SUBJECT: Focused Early Action Corrective Measures Study/Feasibility Study in Support of Beneficial Reuse of Select Coal Ash and Coal Fines at the A-Area Ash Pile (788-A), A-Area Coal Pile Runoff Basin (788-3A), F-Area Ash Landfill (288-F), H-Area Ash Basin (288-H), K-Area Ash Basin (188-K), and L-Area Ash Basin (188-L) Operable Units (SRNS-RP-2024-00222, Revision 1, May 2025) (Redline Pages) and Savannah River Site's Responses to the Regulatory Comments on the Revision 0 Document, SEMS Numbers: 61, 62, 88, 90, & 91

1. SRS Responses to the U.S. Environmental Protection Agency's Comments on the Focused Early Action Corrective Measures Study/Feasibility Study in Support of Beneficial Reuse of Select Coal Ash and Coal Fines at the A-Area Ash Pile (788-A), A-Area Coal Pile Runoff Basin (788-3A), F-Area Ash Landfill (288-F), H-Area Ash Basin (288-H), K-Area Ash Basin (188-K), and L-Area Ash Basin (188-L) Operable Units (SRNS-RP-2024-00222, Revision 0, October 2024) SEMS Numbers: 61, 62, 88, 90, & 91

2. SRS Responses to the South Carolina Department of Environmental Services' Comments on the Focused Early Action Corrective Measures Study/Feasibility Study in Support of Beneficial Reuse

Refined CSMs (Specific Comment #13)

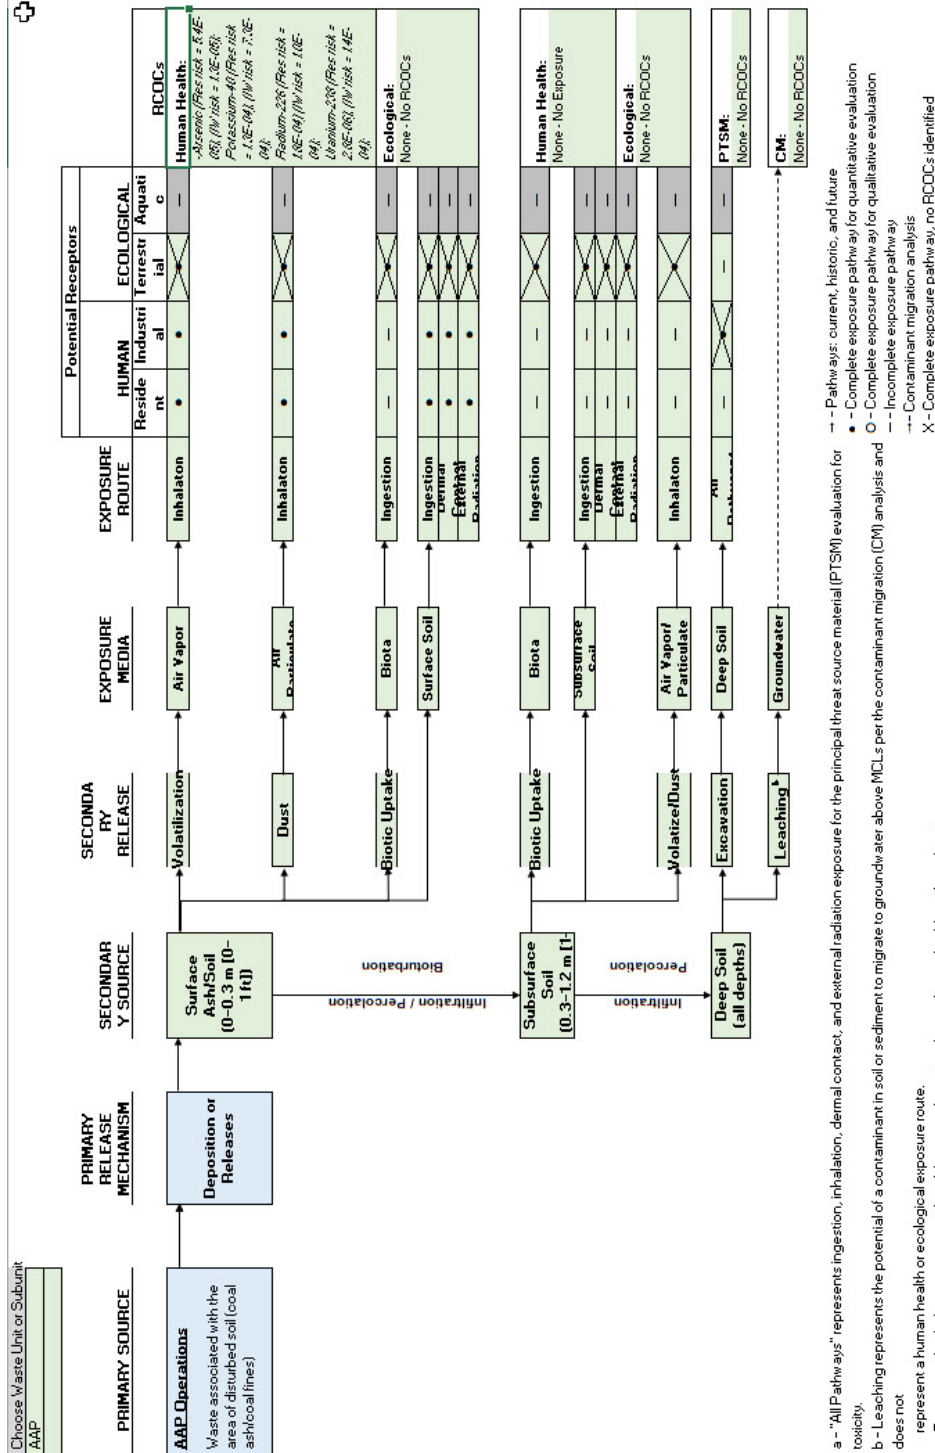
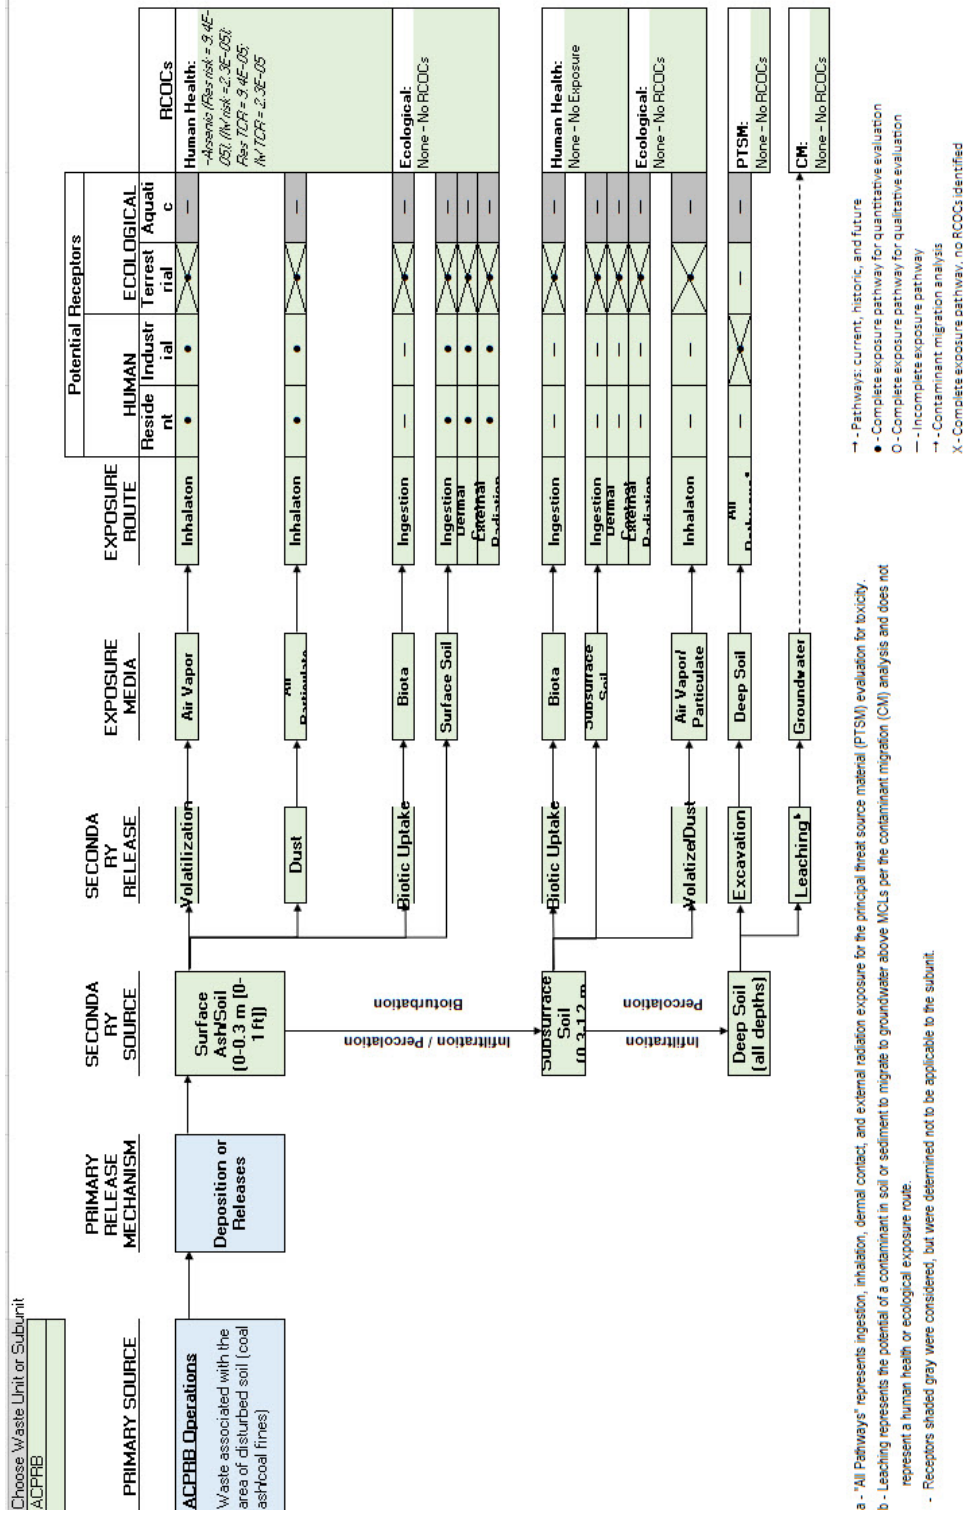
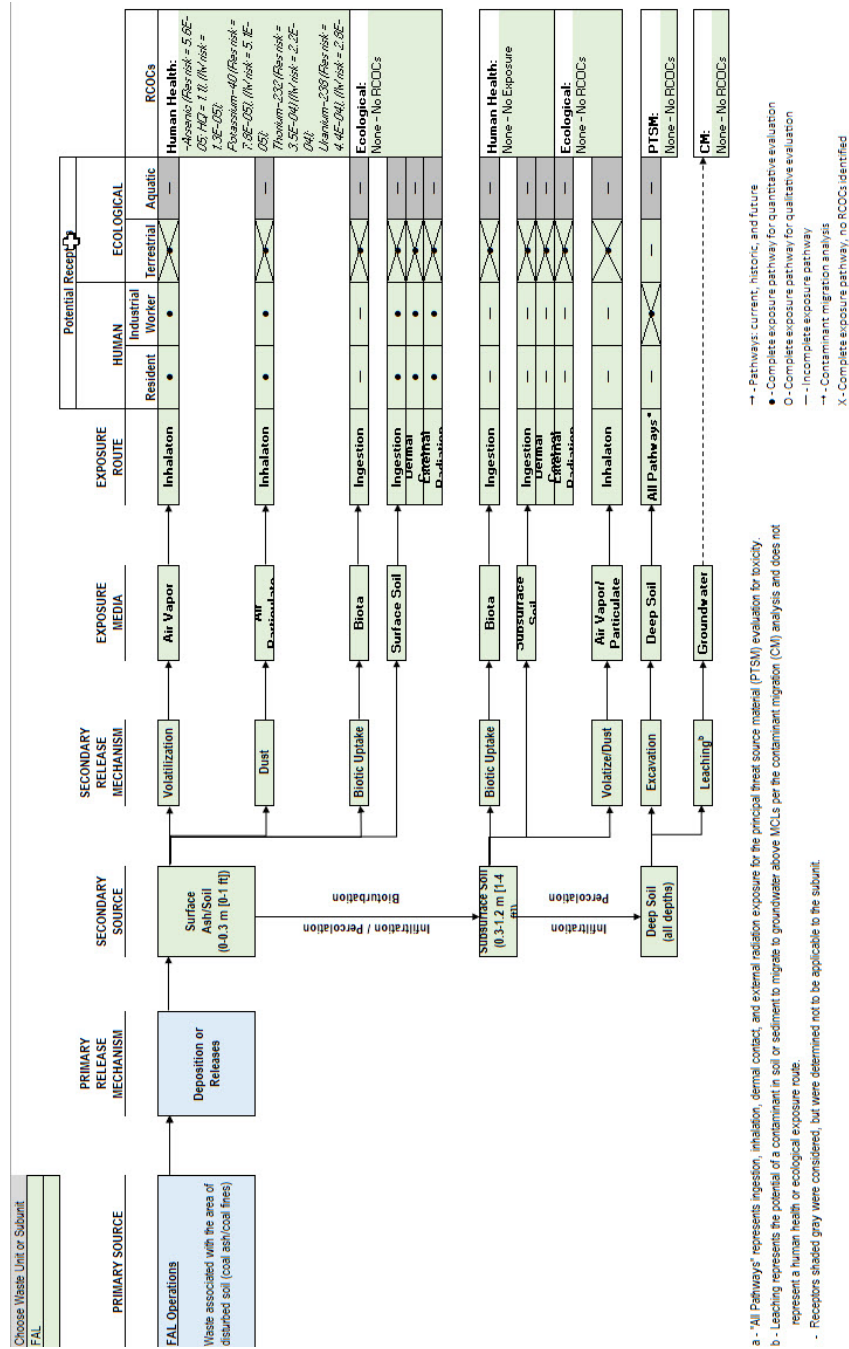
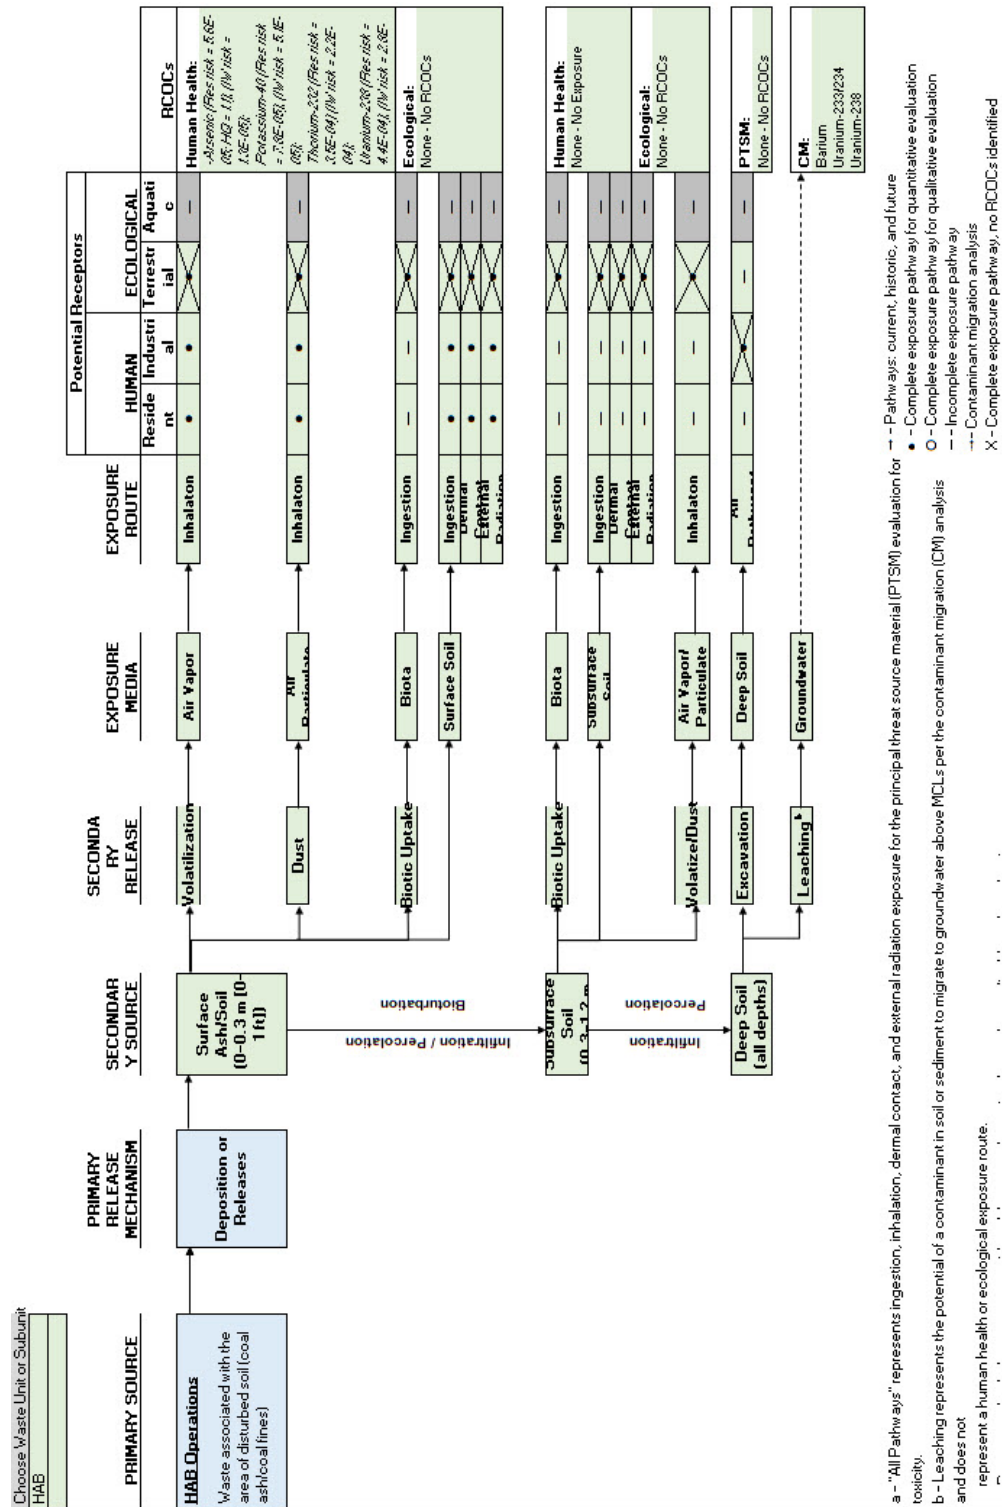
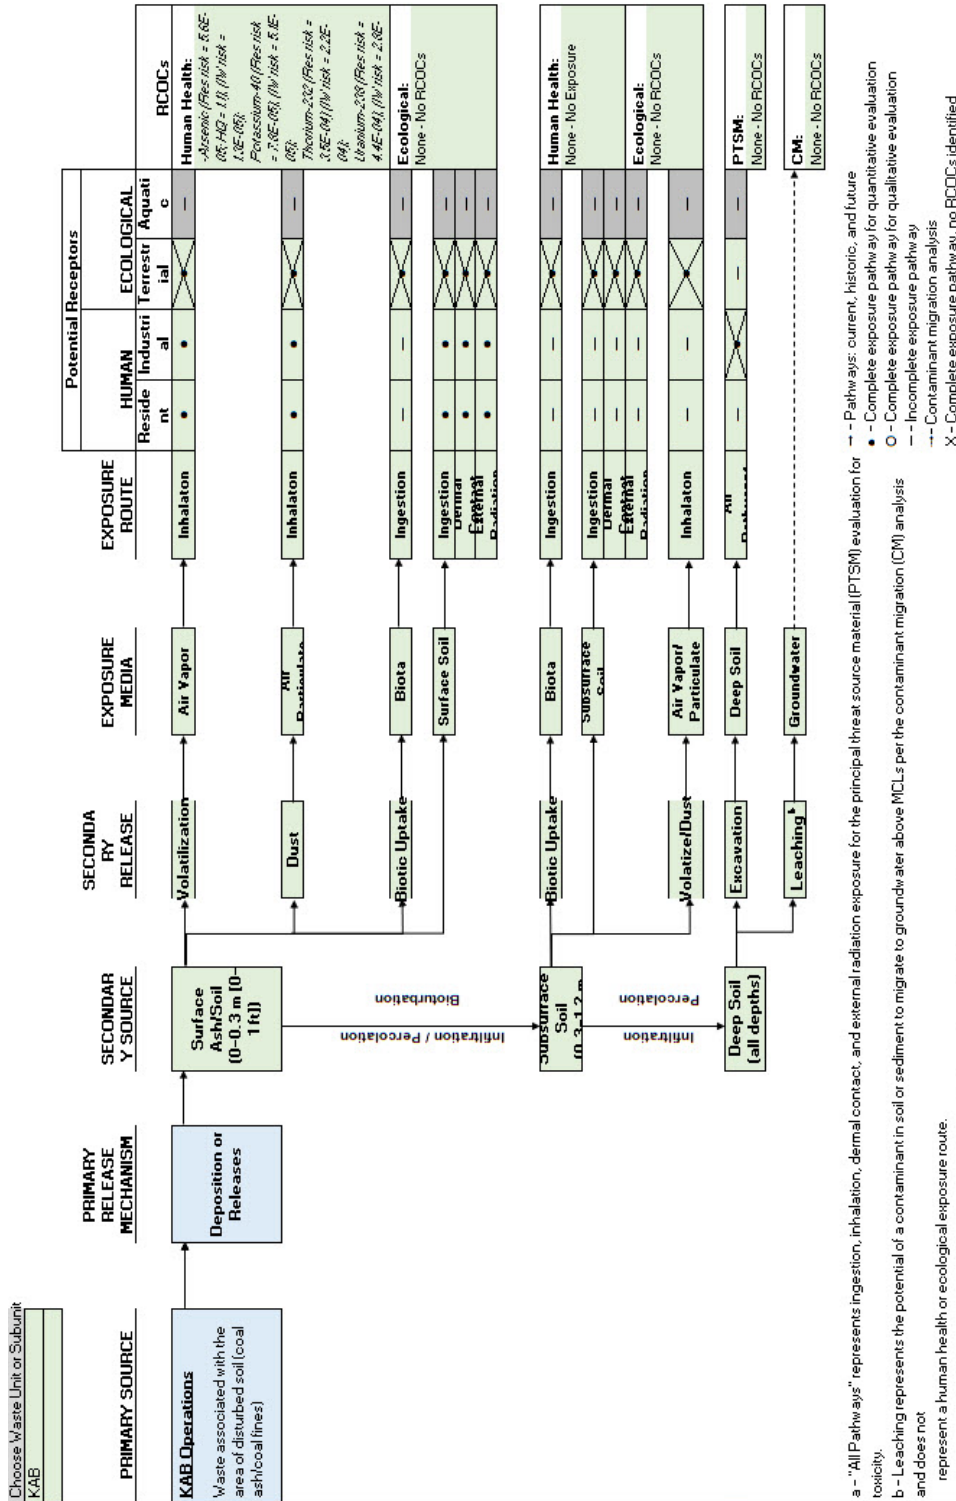
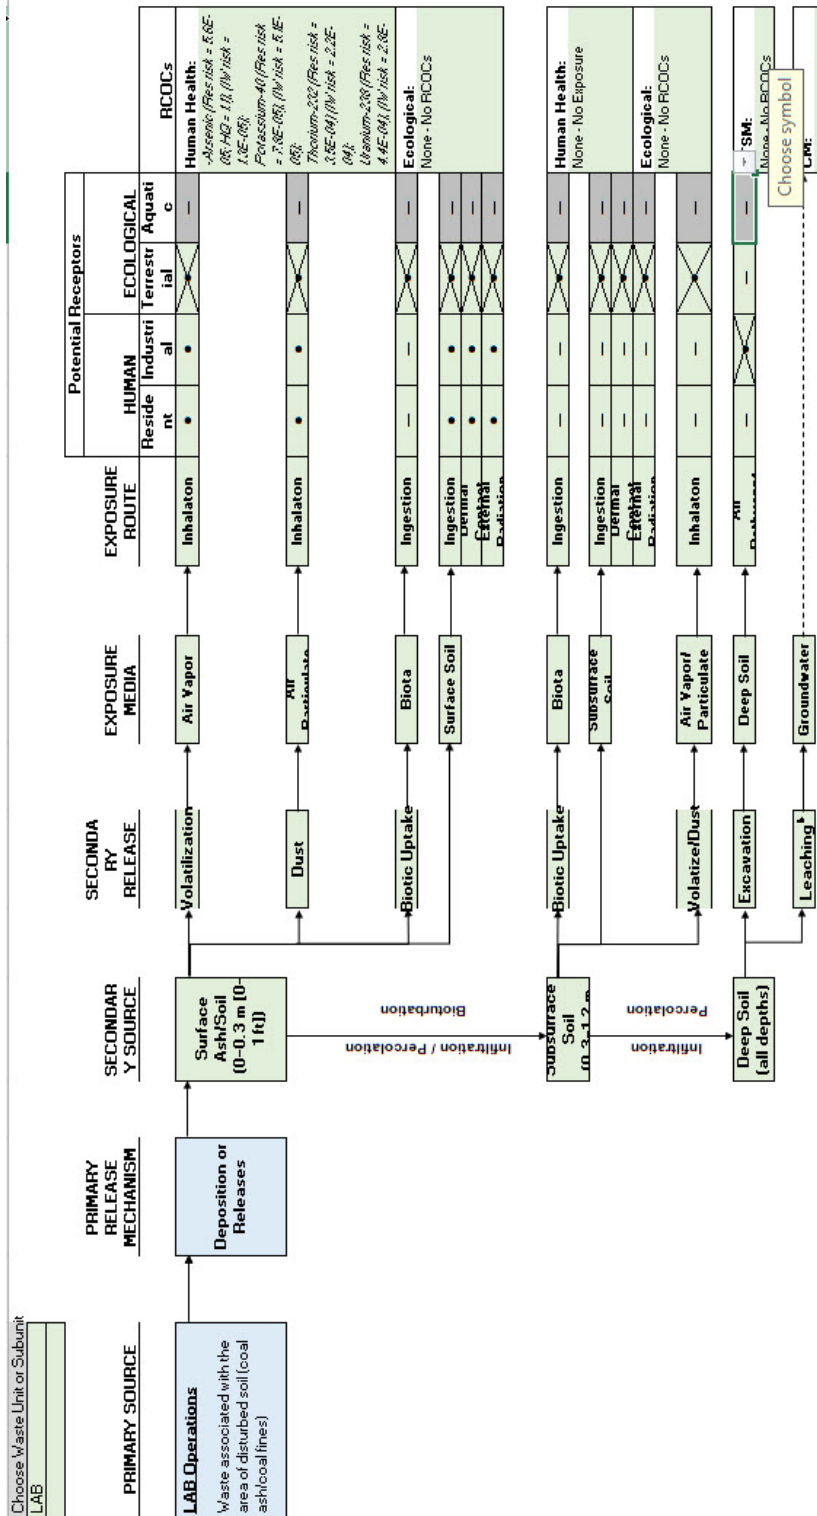
13. **Appendix D, Ecological Risk Assessment, Section D-2.3.4, AAP and ACPRB OU – Soil Medium, Page D-31 of D-112:** It is uncertain why sediment and surface water results are included in this section. Based on the CSMs, there are no complete aquatic exposure pathways on the site. Section D-1.3, Habitats/Receptors/Preliminary Assessment and Measurement Endpoints, mentions that there was marginal aquatic habitat present in this part of the site at one time, but it has become much less appreciable through secondary succession. *Please either revise this section by removing all discussions of risk results based on aquatic exposure pathways, or add a new symbol to the appropriate CSM, indicating that the aquatic exposure pathways were once considered complete but are not currently operating.*

The CSMs will be revised to shade the boxes for the aquatic receptor in gray. A footnote will be added to define the gray shaded boxes as, “indicates that the receptor and media scenarios were considered but are not applicable to the unit.”
